Technical Review – Blue Sky Meats APP-20222295

5 March 2025

PREPARED FOR:

PREPARED BY:

Figure 3-1: Existing and Proposed Planting Plan⁴

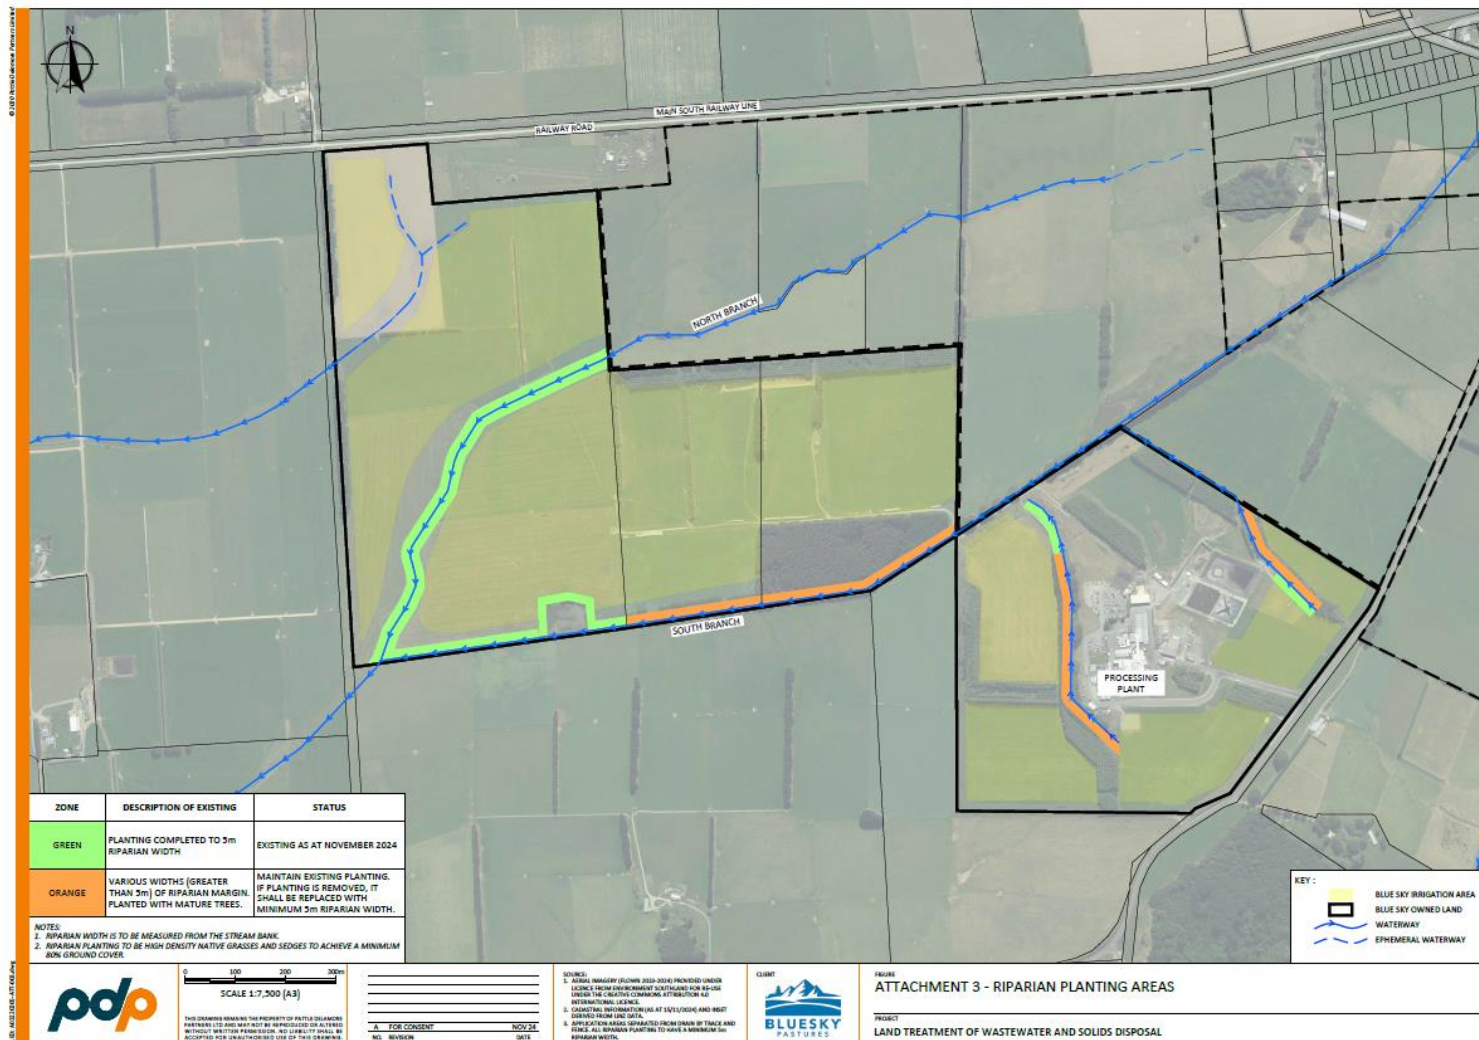
The following issues arose in reviewing the planting programme during the S92 process:

- The plan includes riparian planting along the open-channel streams next to irrigation areas. It excludes the tile drained stream in the north-west of the BSM site and any other tile drains, the reaches of the streams to the north of the processing plant, and also the streams that are in the third party owned land. These tile drains and streams are close to irrigation areas, hence they would be at risk from surface runoff and intercepting shallow groundwater. Whilst the tile drains are not open channels, they represent a discharge route which could be mitigated with planting.

- In the initial application, the planting performed under Stage 1 did not achieve a minimum of 5m width at all locations, which was identified in the current application as being required to reduce effects on the surface water quality. This meant there would have been some inconsistency between the width of existing planted buffers, and that of future ones. This inconsistency has been rectified in the current proposed plan, but the 5m width has been maintained.

- The application indicated that Stage 2 will be undertaken when the phosphorus load exceeds a specified limit. The PDP 2024 letter indicates that phosphorus is already high in the soils and represents a current risk to surface water quality rather than being a future risk as loads increase. This "Stage 2" planting is now part of the existing planting and is no longer a contingency response to increased phosphorus load.

Figure 5-2 Proposed off-site downgradient groundwater monitoring bore locations (yellow circles; adapted from PDP 2023)

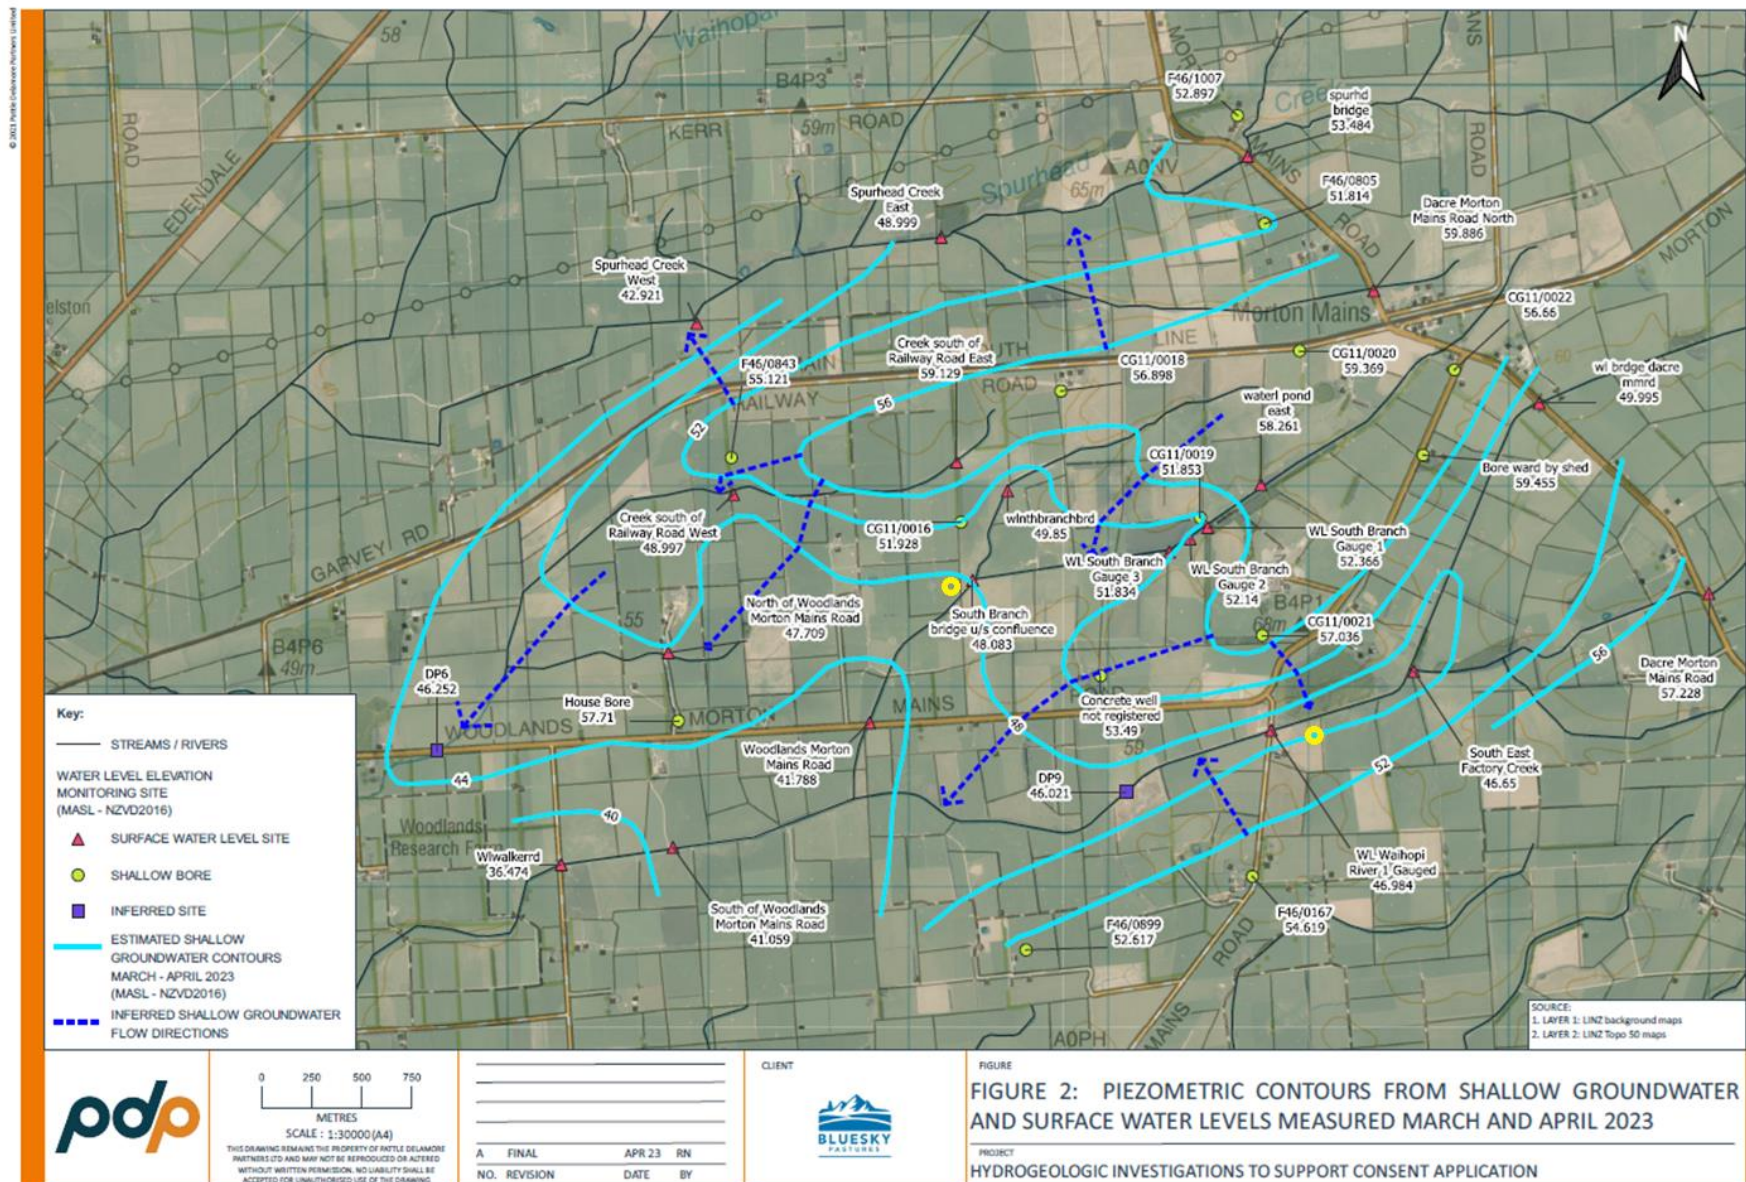
Therefore, we consider it necessary to add at least four further bores (with screening to a depth of approximately 10 mbgl) throughout the site itself and an additional downgradient bore on the southern side of the tributary of Waihopai River. Our justification for this approach is as follows:

- Maintenance of a downgradient bore into the shallow aquifer on the opposite side of the tributary to the site will allow for detection of any contamination that may continue being transported via groundwater beyond the nearby tributary of the Waihopai River (i.e. the component of groundwater flow that is not intercepted by surface water, constituting river baseflow). We recommend that this bore be situated in either of the proposed locations shown on Figure 5-2 below (indicated by yellow circles).

All groundwater monitoring bores including the seven originally proposed by the applicant and the additional five (or more) bores would be monitored quarterly from commencement of the consent as per the proposed Condition 26. This would include recording of referenced groundwater levels and collection of samples across the monitoring network concurrently during each monitoring event (i.e. each event completed within a maximum of 3 days). It is recommended that the groundwater monitoring results are reviewed every six years for the duration of the consent term.

Figure 5-3: OverseerFM Benchmarking Nitrogen Leaching for all Sheep and Beef Farms in Southland Year Ending 2022 Models (BSM shown in Purple) (Figure 14 of PDP 2022 AEE).

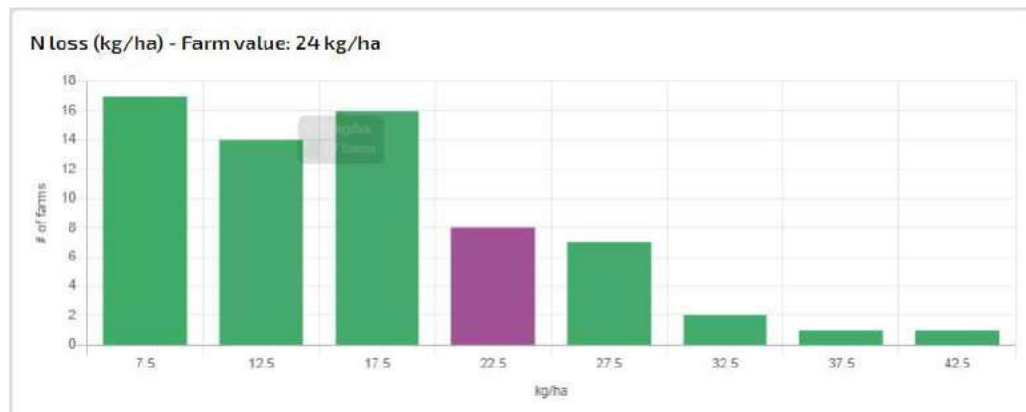
The applicant provided information on the expected nitrogen loads to groundwater as predicted by Overseer, which indicate that the loads for the worst-case modelled, maximum allowed load to BSM land only the predicted nitrogen load to groundwater would be 24 kg N.Ha.Yr. As shown in Figure 5-3, this is at the higher end of the 2022 range of sheep and beef farms for which Overseer modelling is available. Also, it is noted that the site is within an oxidising physiographic zone¹⁰, which has minimal capacity to reduce nitrogen loads within the aquifer.

Figure 5-4: OverseerFM Benchmarking Phosphorus Loss for all Sheep and Beef Farms in Southland Year Ending 2022 Models (BSM shown in Purple) (Figure 15 of PDP 2022 AEE)

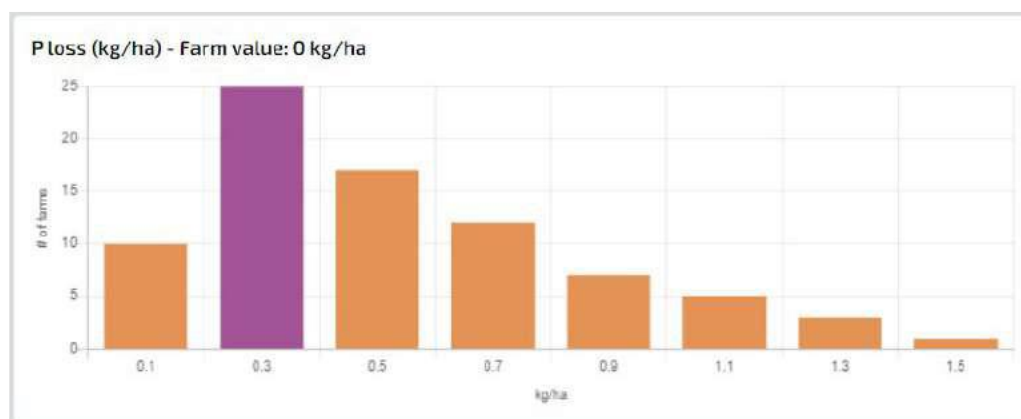
The effects assessment and discussion of mitigation measures is strongly focused on the management of nutrients, particularly phosphorus. As for the nitrogen to groundwater, the PDP 2022 AEE provided the worst case phosphorus loss, which would predominantly be to surface water, using Overseer of between 0.3 to 0.4 kg P.Ha.Yr, which is similar to the majority of sheep and beef farms in Southland in 2022 as shown in Figure 5-4.

The application states that the effectiveness of riparian buffers in reducing phosphorus loss is between 30-90% (i.e. the buffer removes 30-90% of phosphorus mass from runoff before it reaches the tributary) (Abu-Zreig et al. 2003 in 2022 AEE, p64). The application assumed the most conservative end of this range, at 30% effectiveness. The riparian buffers will be relied upon to ensure that 'the proposed activity will result in less phosphorus loss to surface water than is currently occurring' (2022 AEE, p64).

We note the 2023 Land and Water Science soil monitoring (provided with PDP letter of 23 February 2023) indicates that phosphorus concentrations in the soil are high, and are expected to remain so, indicating the significant risk from surface runoff from the site to the streams and connected water bodies. Figure 3-1 shows the proposed planting programme for the site. Initially, the plan had two stages: the planting which are already been undertaken (Stage 1) and the additional planting which is proposed when applied phosphorus load exceeds a nominated limit (Stage 2). The November 2024 version of the Plan removed this staging. Issues that have been identified with the programme are given above.
